AGENDA
CITY OF BERKELEY LAKE
PLANNING & ZONING COMMISSION
NOVEMBER 10, 2026 at 7:15 PM
4040 South Berkeley Lake Road
Berkeley Lake, GA 30096

City of Berkeley Lake
Staff Analysis

CASE NUMBER:	PZV-26-06, 826 LAKESHORE DR.
RELIEF REQUESTED:	REBUILD DOCK IN SAME LOCATION AND NON-CONFORMING WITH REGARD TO OPPOSITE SHORE SETBACK
EXISTING ZONING:	R-100, SINGLE FAMILY RESIDENTIAL
PROPOSED USE:	DOCK/DECK OVER LAKE BERKELEY
APPLICANT:	WAYNE MITSCH 826 LAKESHORE DR. BERKELEY LAKE, GA 30096
OWNER:	SAME AS APPLICANT
MEETING DATE:	NOVEMBER 10, 2026 P&Z COMMISSION

CASE NUMBER:	PZV-26-07, 40 LAKESHORE DR.
RELIEF REQUESTED:	6-5 FOOT REDUCTION IN SIDE SETBACK, 1.24% INCREASE IN ALLOWABLE BUILDING COVERAGE,
EXISTING ZONING:	R-100, SINGLE-FAMILY RESIDENTIAL
PROPOSED USE:	SINGLE-FAMILY HOME
APPLICANT:	VINH NGUYEN 40 LAKESHORE DR. BERKELEY LAKE, GA 30096
OWNER:	SAME AS APPLICANT
MEETING DATE:	NOVEMBER 10, 2026 P&Z COMMISSION

SHEET TITLE
RECOMBINATION PLAT

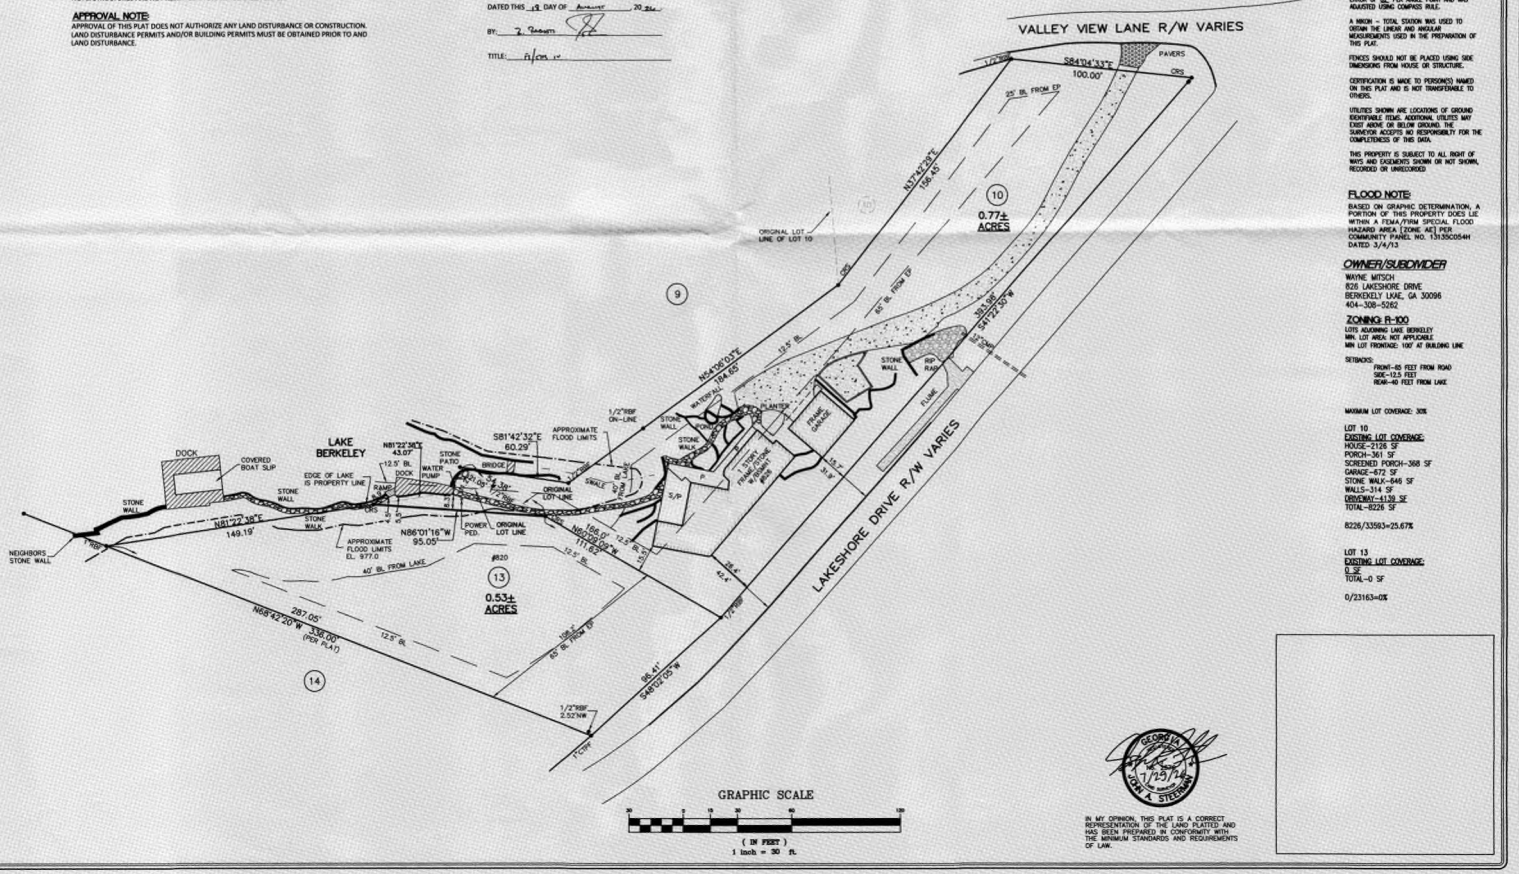
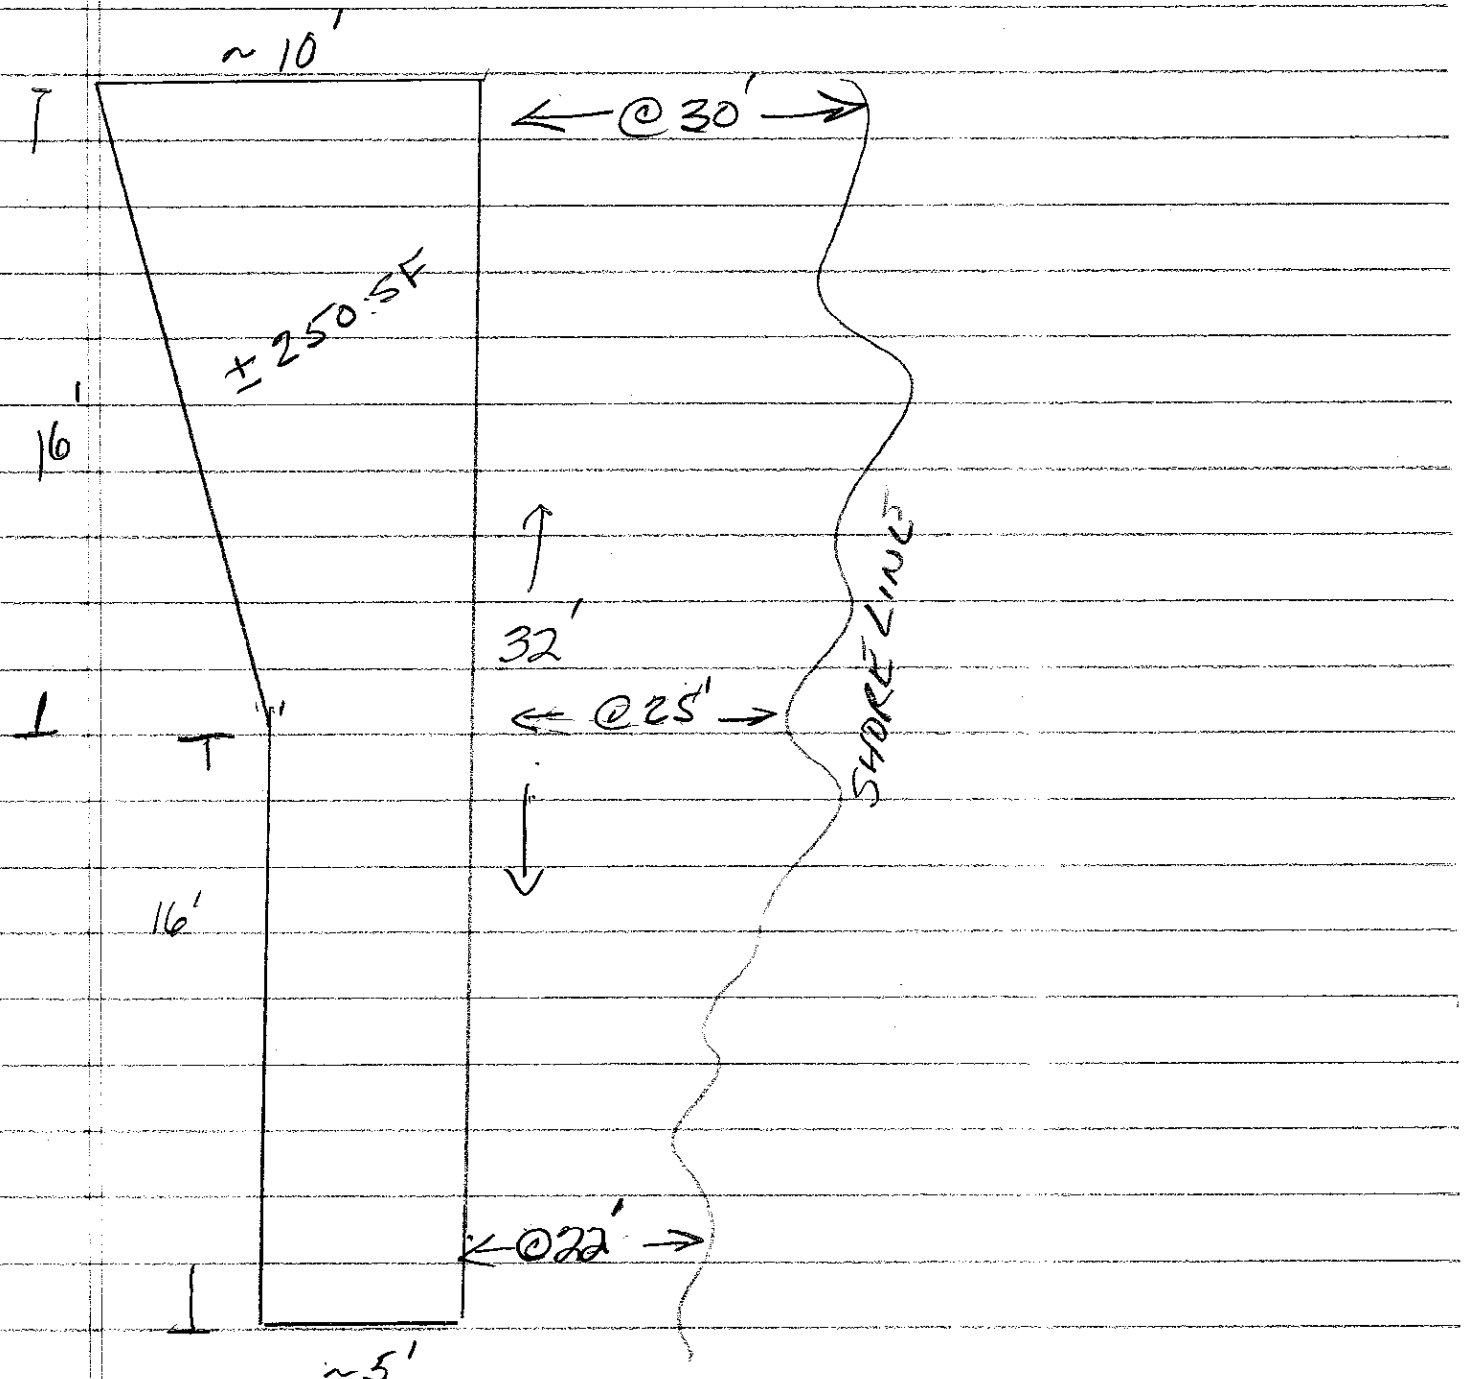
2.) This dock is non-conforming with respect to the 75-foot opposite shore distance requirement and possibly with respect to the 12.5-foot side setback applied to docks and boathouses.

3.) According to the application materials, the dock is about 22 feet from the opposite shore at the closest point, 53 feet closer than required by Section 78-89(g)(3).

4.) Based on the recombination plat, the dock sits approximately 5 feet from the side lot line on land, but once projected into the lake, it meets the 12.5-foot setback requirement. Staff approved the recombination as submitted. However, if the Commission deems the 12.5-foot requirement to also apply from the land side of the dock, then a variance is needed to Sec. 78-89(g)(2).

40 Lakeshore Drive SITE PLAN

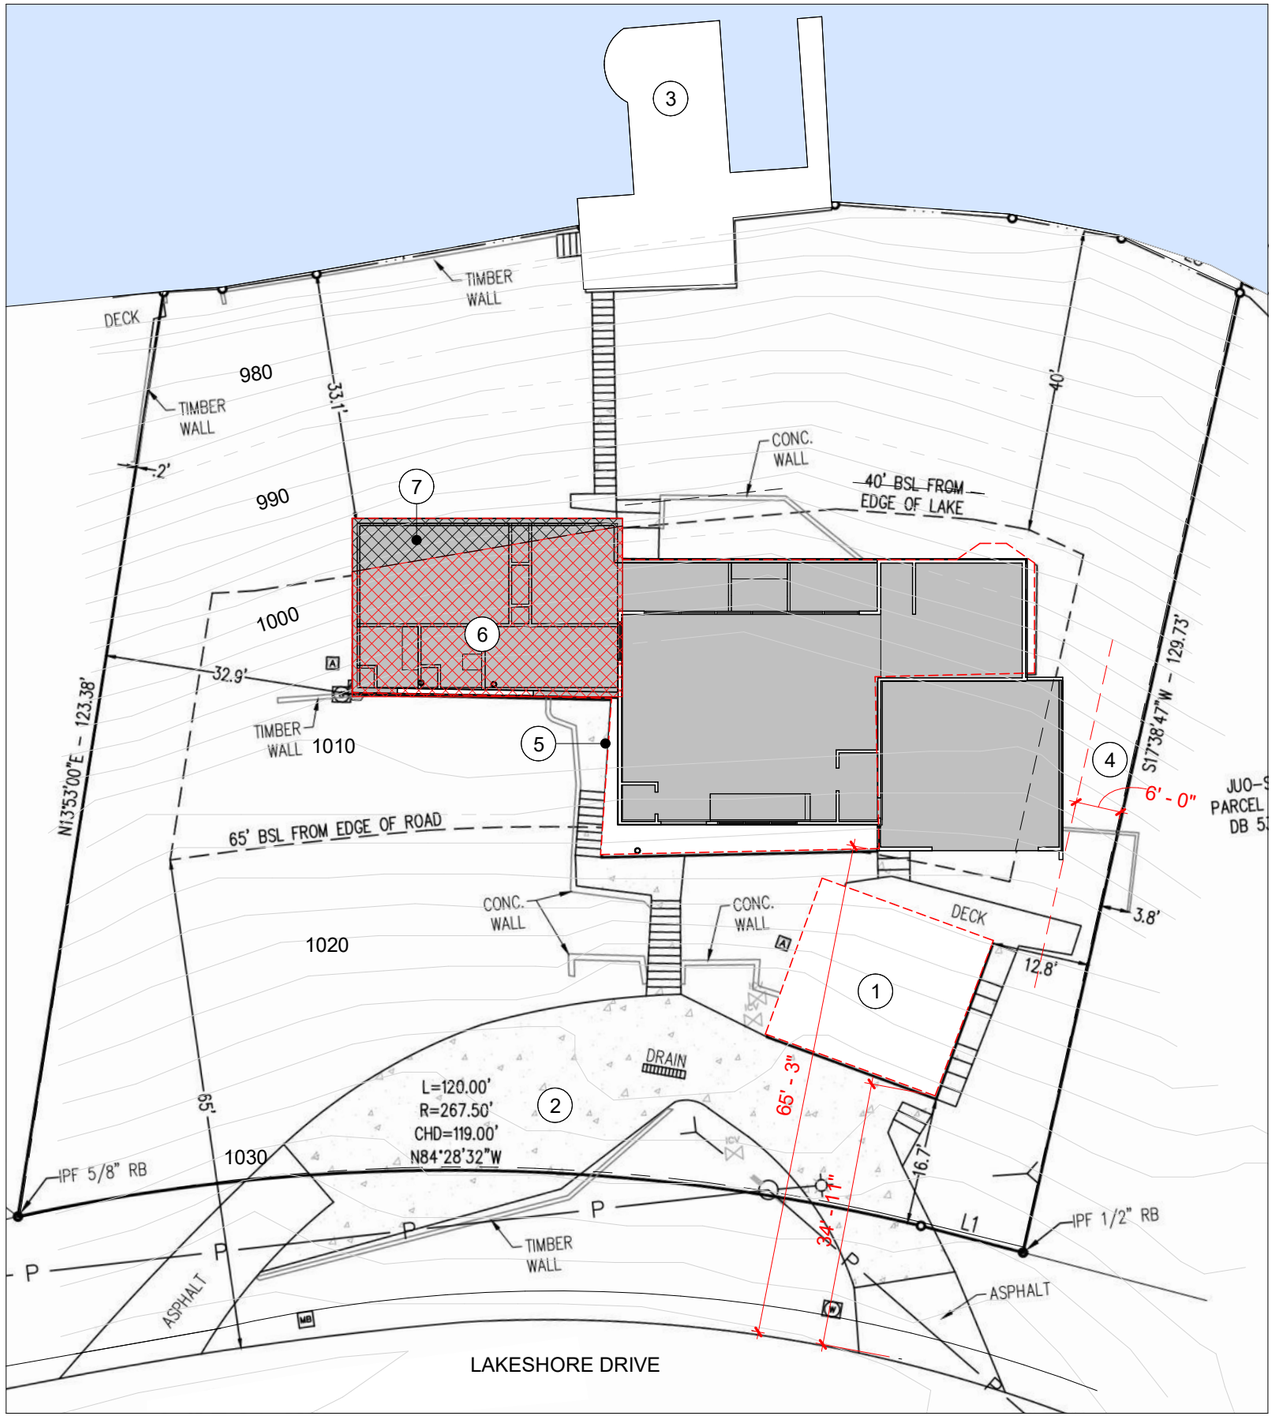
This project consists of a modification/addition to an existing home and demolition of a detached garage. A portion of the existing home is to remain, while the remainder will be torn down and replaced according to the attached site plan. The re-built portion of the house will include a second story, as viewed from Lakeshore Drive, that doesn't exist today, and will be located 6 feet from the side setback, less than half of the required 12.5 feet.

The current detached garage, proposed to be demolished, meets the 12.5-foot side setback but is located in front of the house and 30 feet closer to the edge of Lakeshore Drive than the required 65 feet. The new portion of the home will include an attached garage and will meet the front setback but has resulted in the need for the side setback variance (Sec. 78-197(7)).

4.) The removal of the detached garage and re-design to include the garage within the footprint of the house improves one non-conformity but adds the need for a 6.5-foot side setback variance (Sec. 78-197(7)).

5.) At 31.63%, the current impervious surface areas are non-conforming with regard to the 30% lot coverage limitation.

6.) At 30.31%, the proposed impervious surface areas will still exceed lot coverage standards but will become less non-conforming.

8.) With the addition of a second story, the new building coverage limitation will be 15%. At 16.24%, the proposed building coverage requires a variance from Sec. 79-197(11).
